**PLANNING & DEVELOPMENT SERVICE
PLANNING DIVISION**

RE: Staff Memo – Initial Architecture and Site Review (IASR) for Lot 1004BR,
TBD Victoria Drive.

**APPLICATION OVERVIEW: New Single-Family Home on Lot
1004BR**

AD ADDRESS MONUMENT
 SCALE: NTS

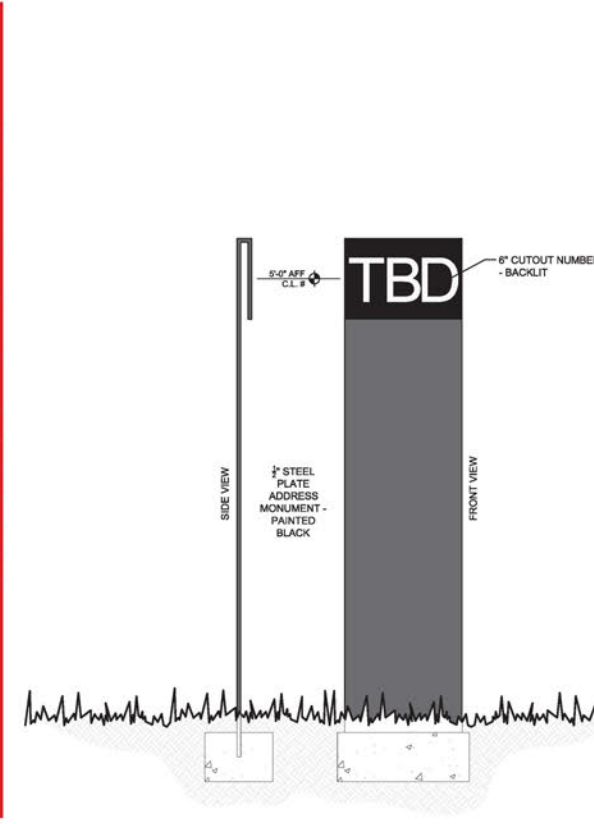
Staff: The applicant provided an address monument on Sheet A1.3. The monument is proposed as a black steel plate address with cut out numbers. The applicant has noted the letters will be backlit. This should be revised to downlit to meet CDC requirements. The applicant should also provide a light fixture for the address monument prior to Final Review.

- 3) Prior to final review, the applicant shall provide a light fixture for the address monument that meets CDC requirements.
- 4) Prior to final review, the applicant shall provide the dimensions of the retaining wall associated with the driveway.

C2.1

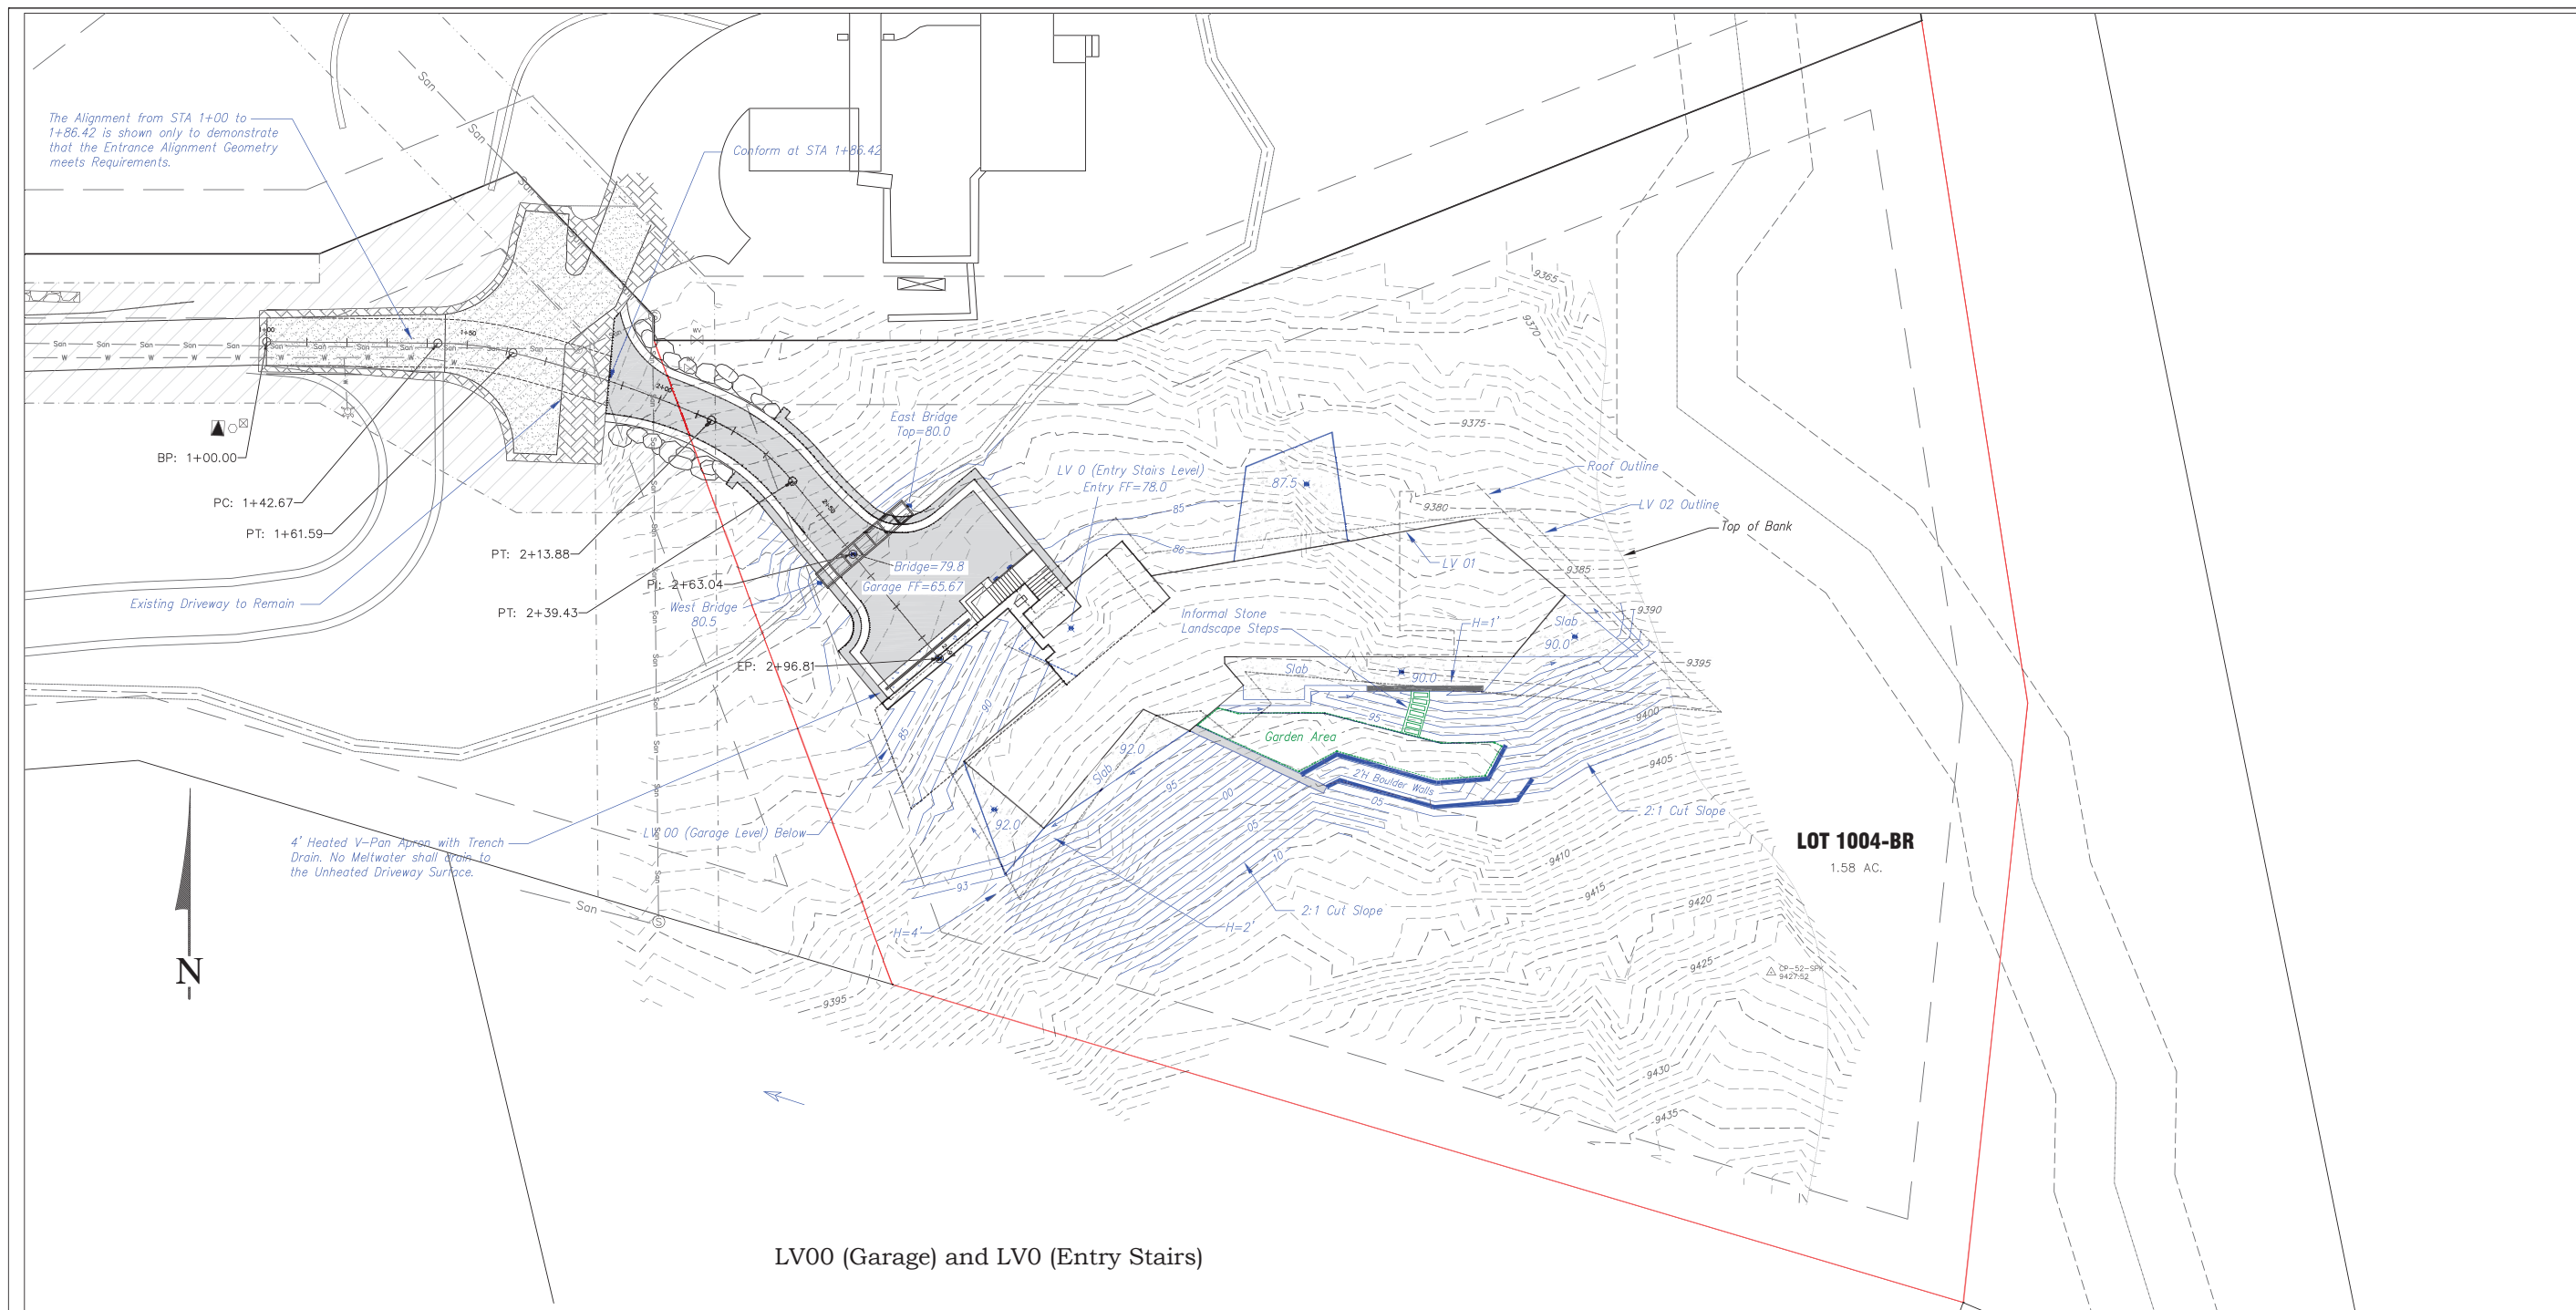
- *Utilities: The applicant has provided a utility plan for Lot 1004BR demonstrating the proposed locations of utility lines and connections. The utilities are shown running up the driveway to connect to Victoria Drive.*
- *Landscaping: There is proposed natural landscaping within the setbacks of the home.*
- *Driveway and associated boulder walls: The driveway as shown takes access from Victoria Drive and crosses the General Easement to the home. The driveway has associated boulders for retainage shown on Sheet C2.1.*

Driveway Profile
Station

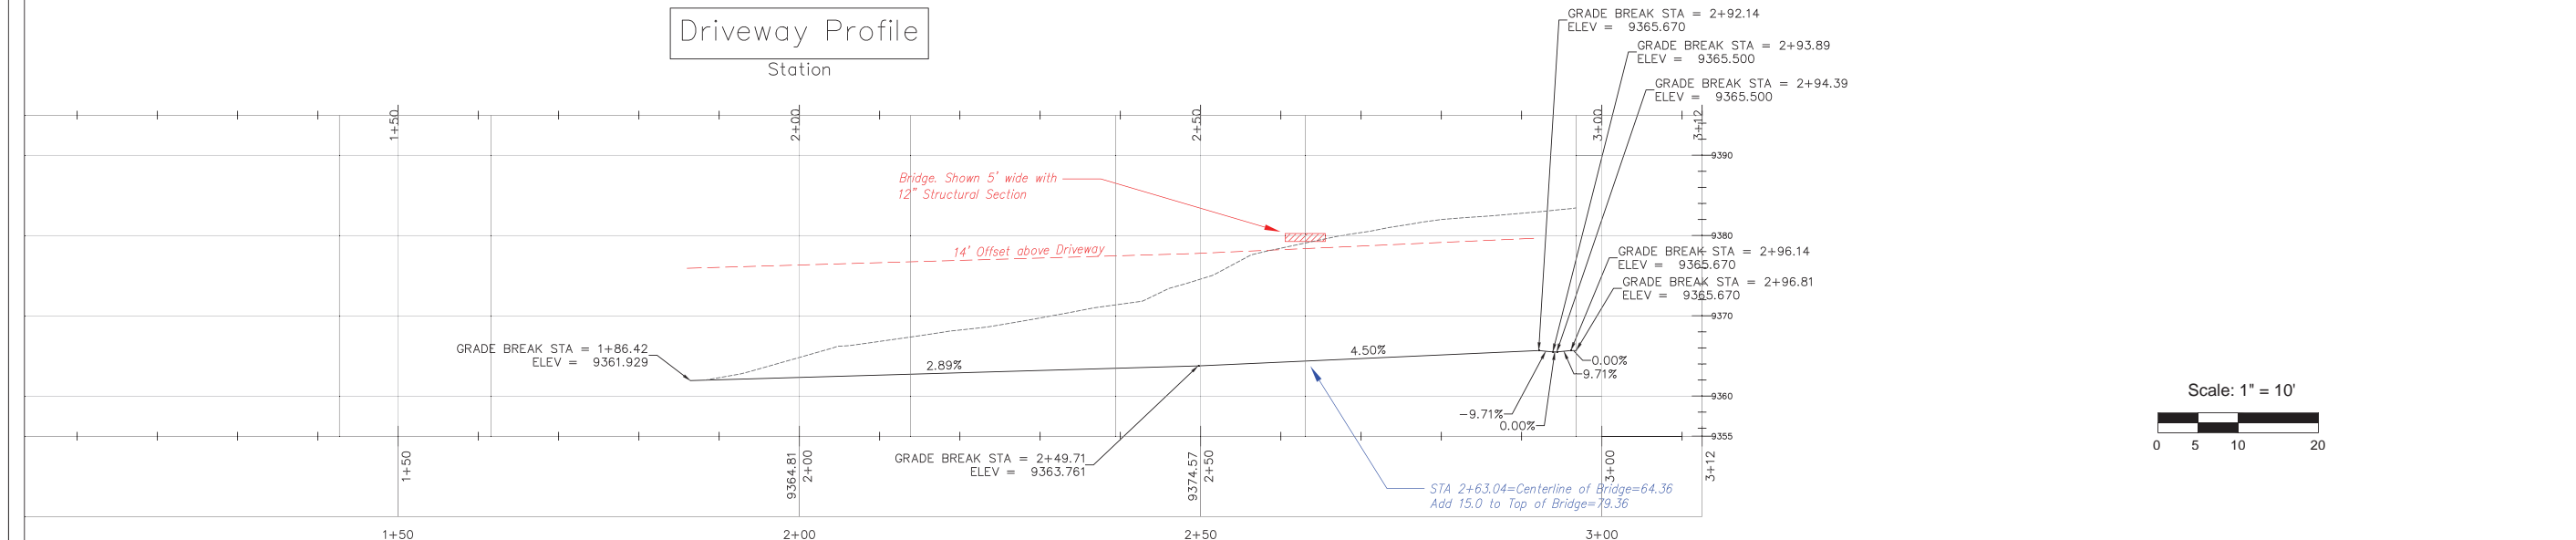
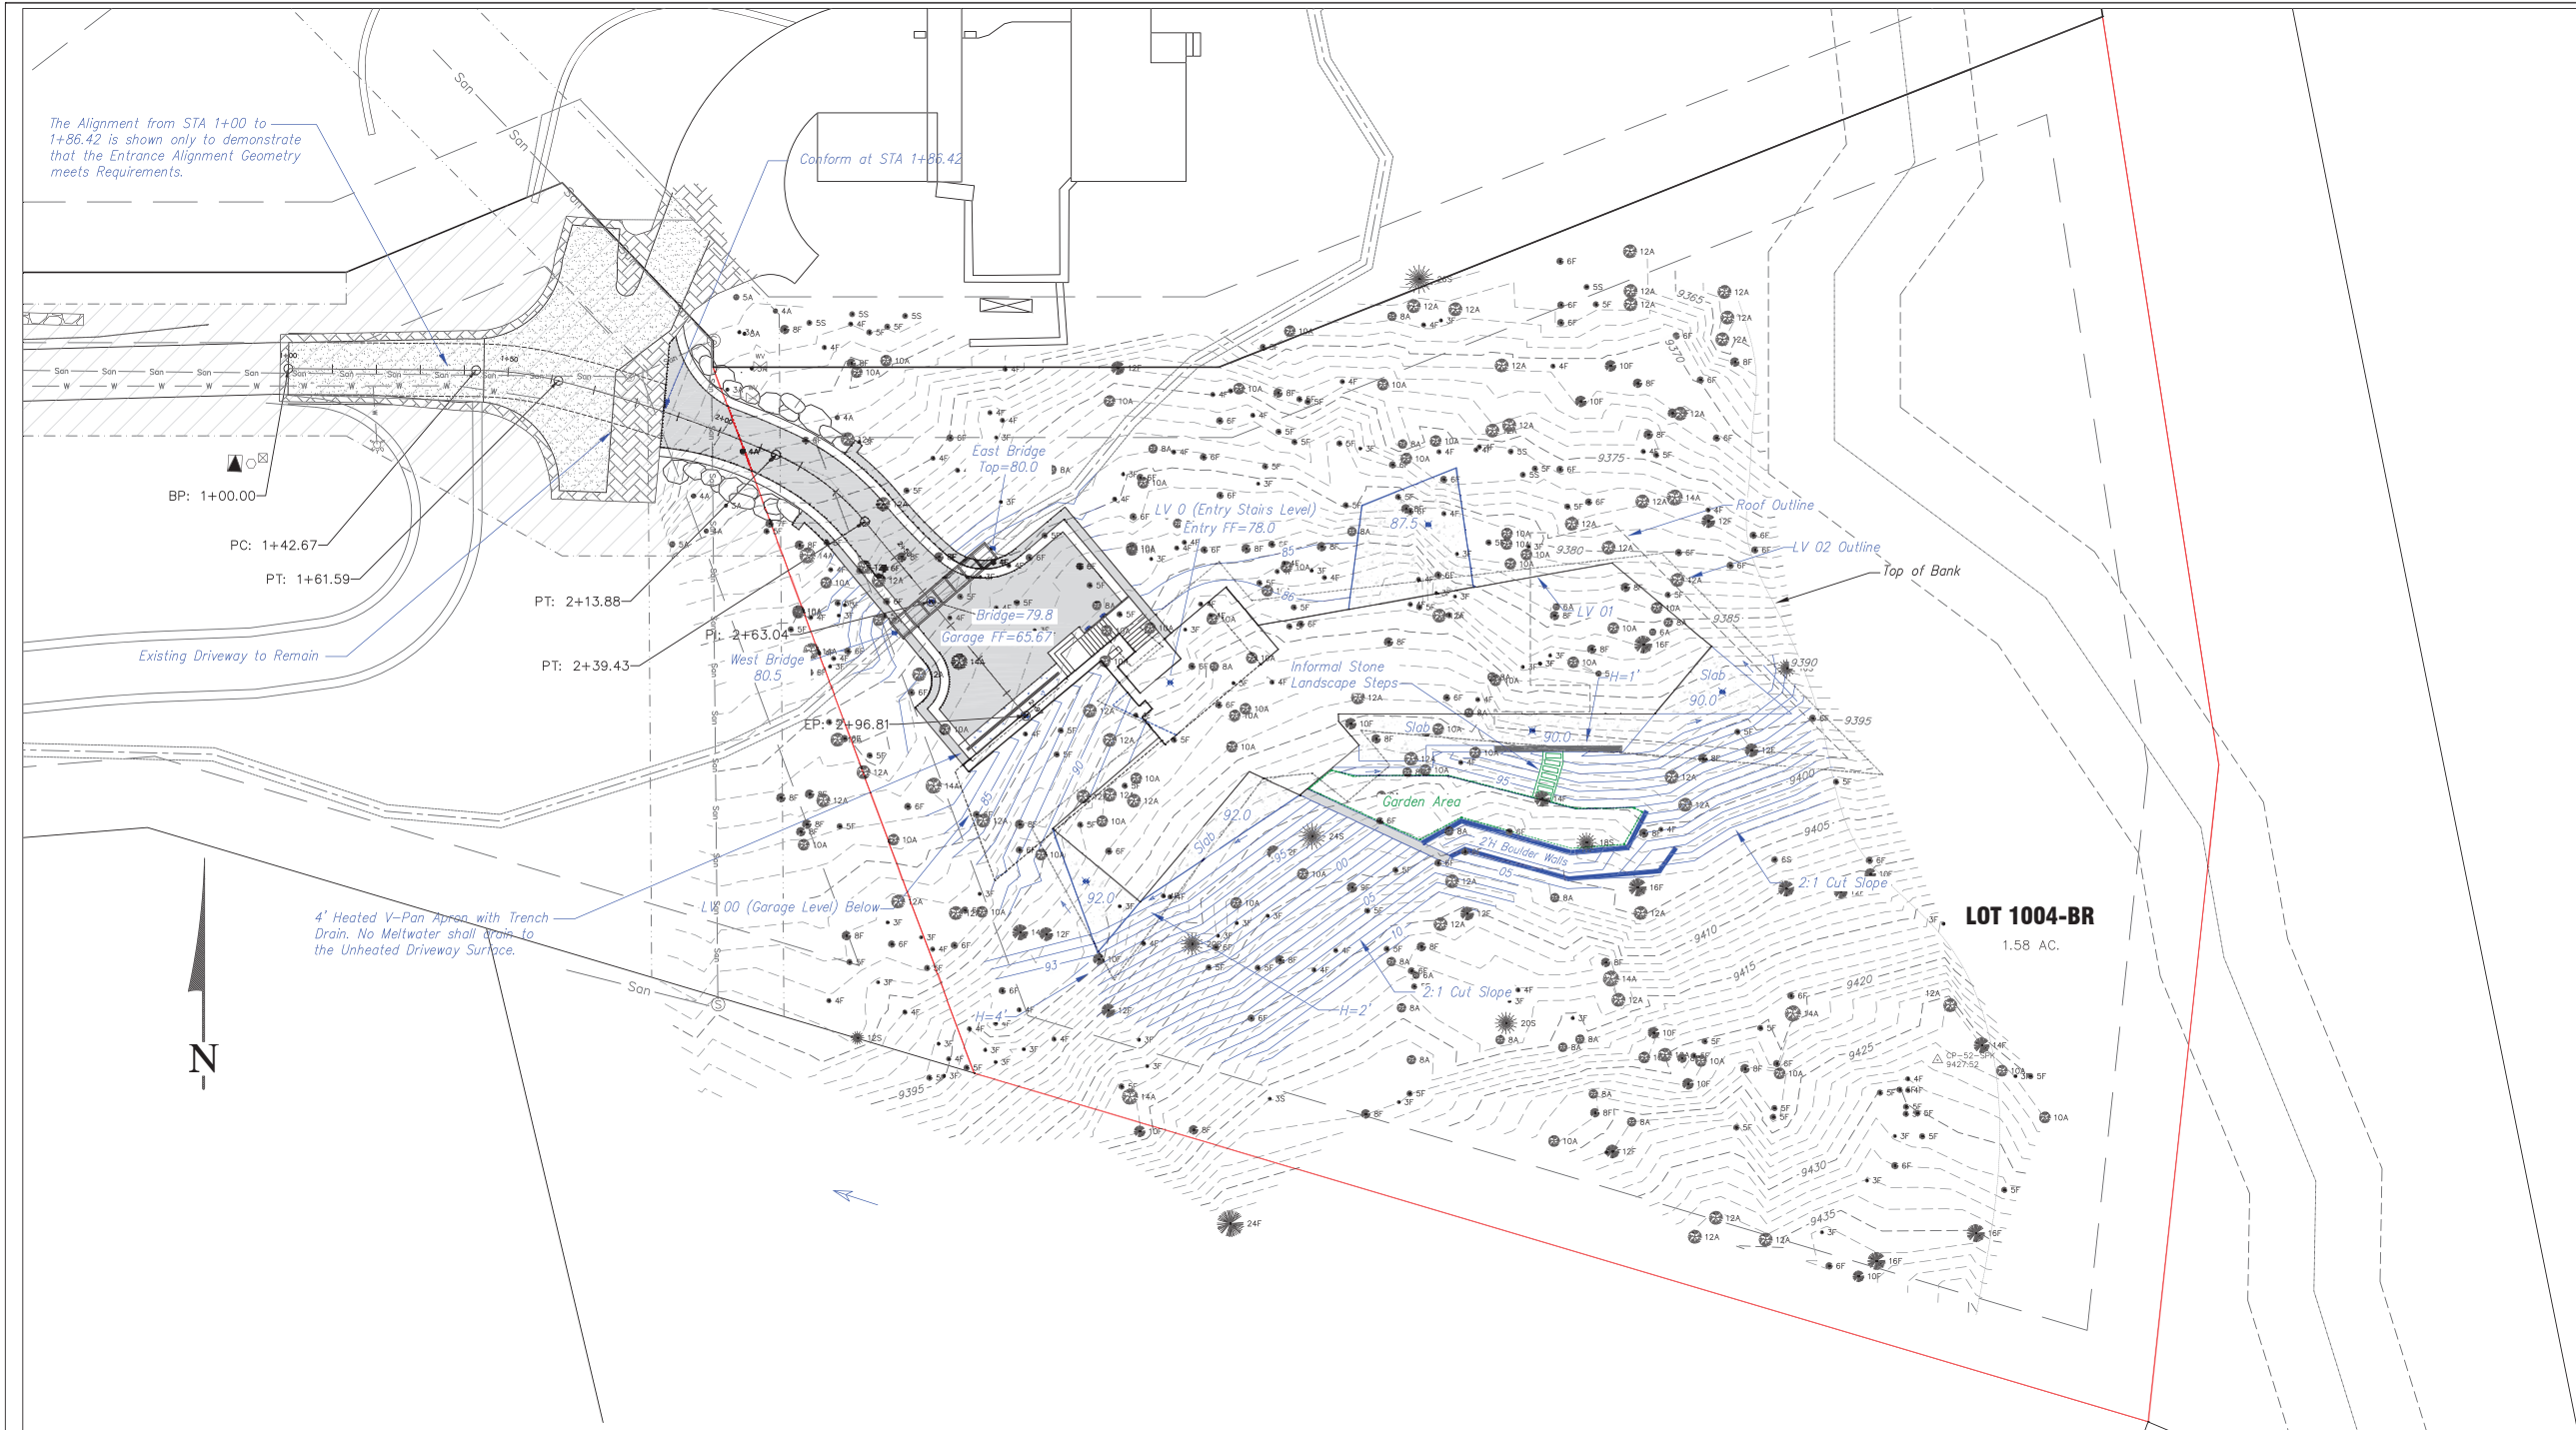
Staff: The applicant has provided a driveway plan on Sheet C2.2. The driveway grade ranges between 2.49% and 9.71%. The maximum allowable driveway grade is 8%. DRB special approval is required to approve the proposed driveway grade. The section of 9.71% is only about 1.5' in length and is intended to keep water from flowing down the driveway. The plan notes a 4' heated V-pan apron at the garage/Moreover, the applicant should provide further detail regarding the dimensions of the driveway width and length to ensure that it is meeting CDC requirements. Boulder walls for retainage are shown near Victoria Drive. A drawing detail of the boulder walls were shown on Sheet C1. The sheet notes that the height of the walls will vary but will not exceed 6'. The maximum retaining wall height for walls associated with driveways is 5' (CDC 17.6.6.A.6.a). The walls should be revised to meet CDC requirements. Moreover, the driveway also has retaining walls on either side as it connects to the below grade garage. A detail of the retaining wall is shown on C1. However, the dimensions are not shown. The dimensions of the retaining walls should be provided prior to final review. The driveway crosses under a ski bridge. More information should be provided on the materiality and surface of the ski bridge.
